From: Bratcher, Mike, EMNRD
Sent: Tuesday, November 13, 2012 2:19 PM
To: 'Cliff P. Brunson'
Cc: Chris Jones; Ken Swinney; Kathy Purvis; Jennifer Gilkey
Subject: RE: Oxy-Righthand Canyon 35 Federal #7 SWD

Reference: OXY USA * Right Hand Canyon 35-7 * 30-015-34529 * K-35-21s-24e * Eddy County, New Mexico
OCD Tracking Number: 2RP-828 * Date of release: 6/30/11

Righthand Canyon 35 Federal #7 SWD

BBC International, Inc.	
Oxy	
Righthand Canyon 35 Fed #7 SWD	
Date: 04/10/12	DRWG by: K. Purvis
NOT TO SCALE	File: Oxy 2012

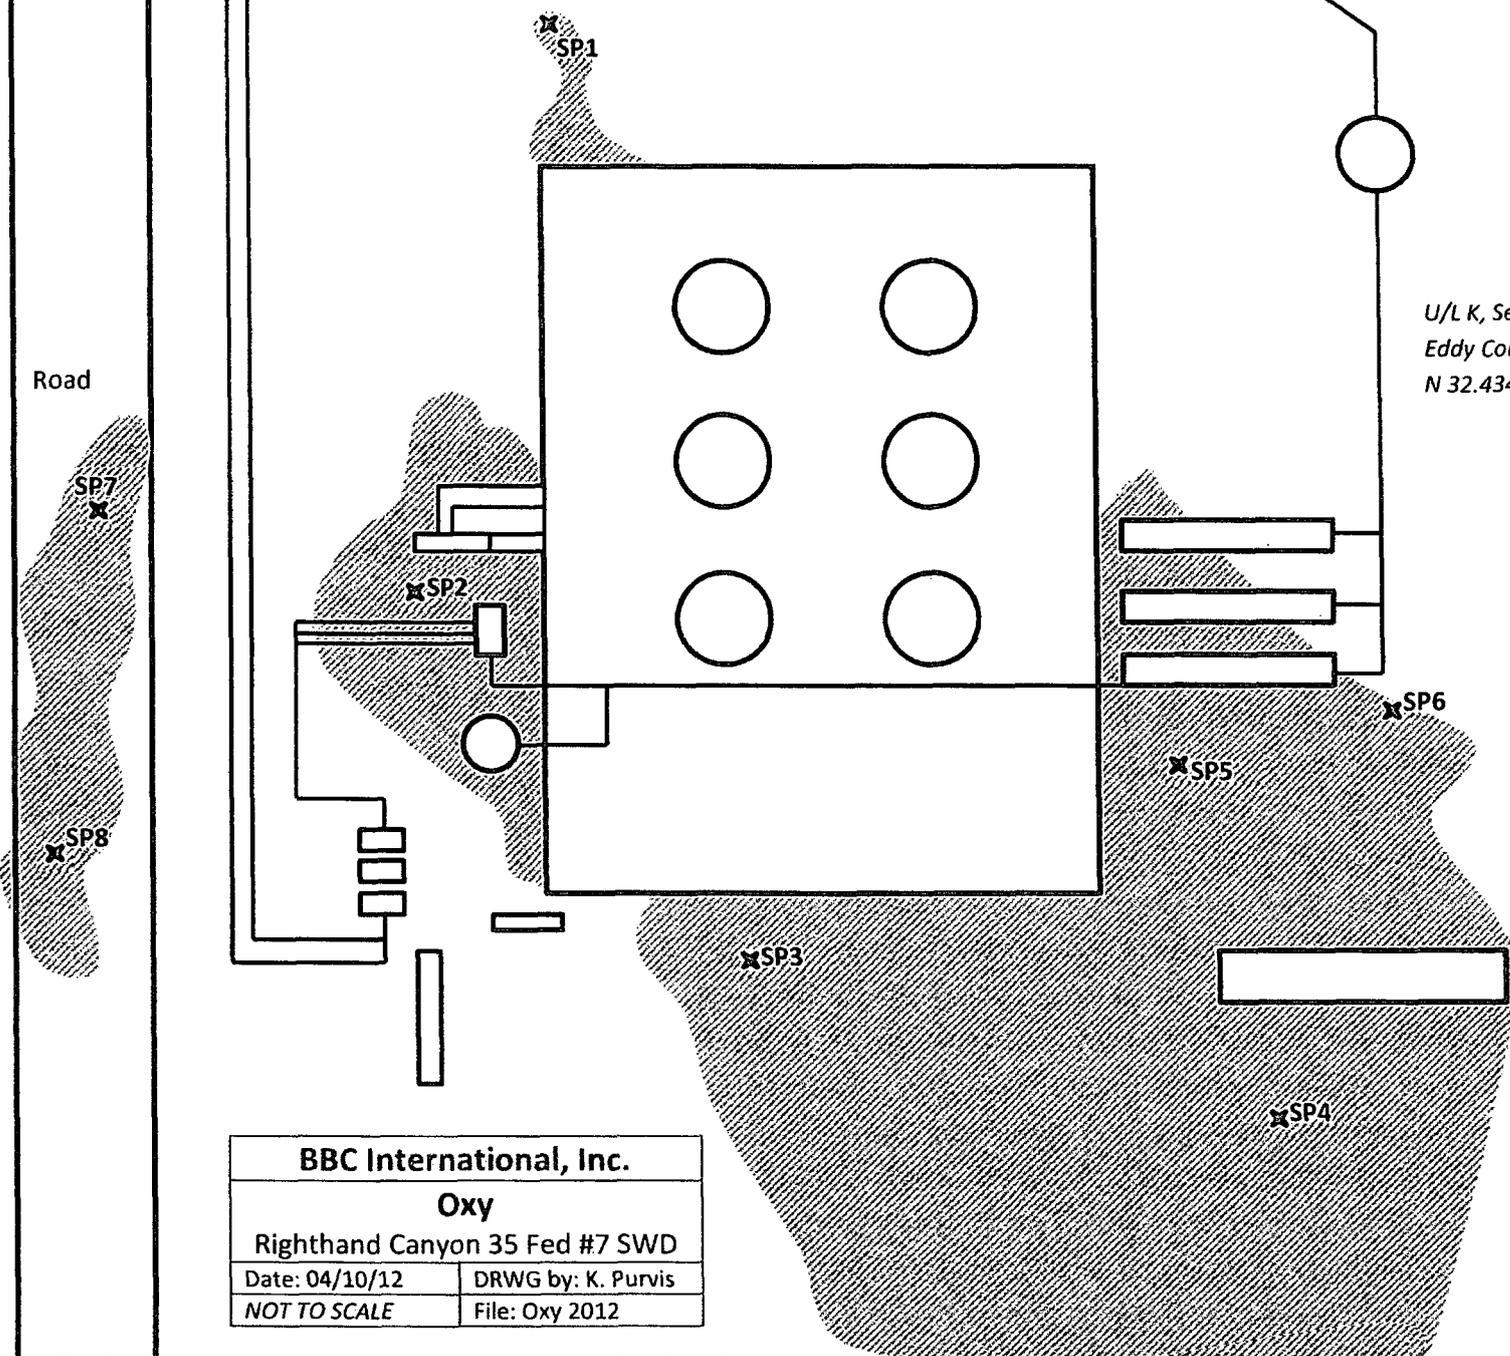
As discussed, it is OCD's understanding that the areas identified as SP7 and SP8 are situated on the access road. OXY indicates that it is not practicable to excavate in these areas due to the steep grade of the road.

This e-mail is to confirm our discussion on September 5, 2012 concerning the remediation plan for the release that occurred at the Oxy Righthand Canyon 35 Federal #7 SWD. As agreed, Oxy will excavate 1 foot across the spill area except in the areas covered by SP4 - SP6 which will be excavated to a depth of 2 feet as depicted on the attached site diagram. In addition, the impacted soil inside the battery containment will be removed off the liner and replaced with clean material. The excavation will then be backfilled with clean soil. The depth to groundwater in this area is approximately 75 to 80 feet.

Your proposal for remediation of the above referenced release is approved with the following conditions/stipulations:

- Notify OCD 48 hours prior to commencement of remedial operations.
- Notify OCD 48 hours prior to obtaining samples where the analyses are to be submitted to OCD.
- Obtain representative confirmation samples of bottom and sidewalls of excavation.
- Obtain approval prior to backfilling excavations.
- Submit a closure report and Form C-141 marked Final Report upon satisfactory completion of project.
- Approval by BLM or any other regulatory authority as may be applicable.
